CITY OF OXNARD

Alterations and Additions for the
Existing Housing Development
CAL 31-1, 31-2, 31-3

CHANGE ORDER G-13

OXNARD HOUSING PROJECT, CAL. 51-3

CURB FOR EXHAUST FAN
3'-1'-0"

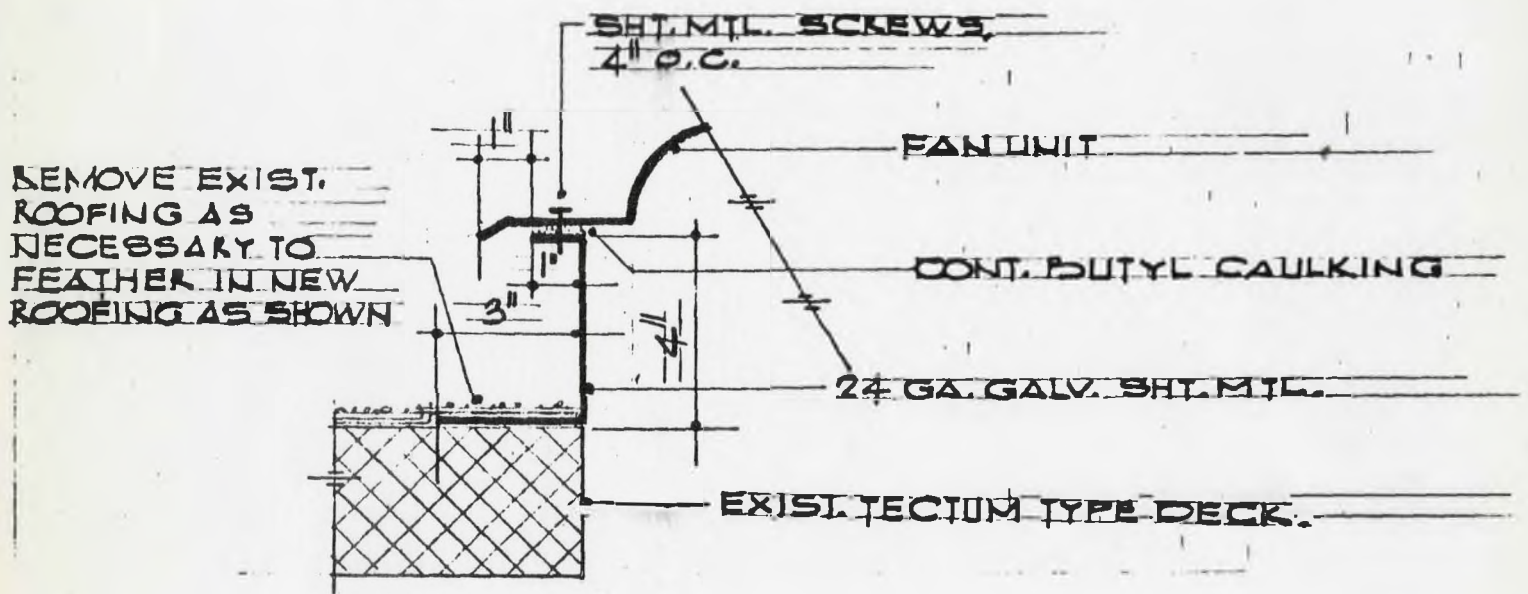
CAL 31-3 ONLY: Provide a 4" high metal base, as detailed on attached Change Order Drawing No. 13, for each bathroom exhaust fan unit. This base is to prevent normal rainwater build-up (due to low pitch of roof) from damaging fan motor.
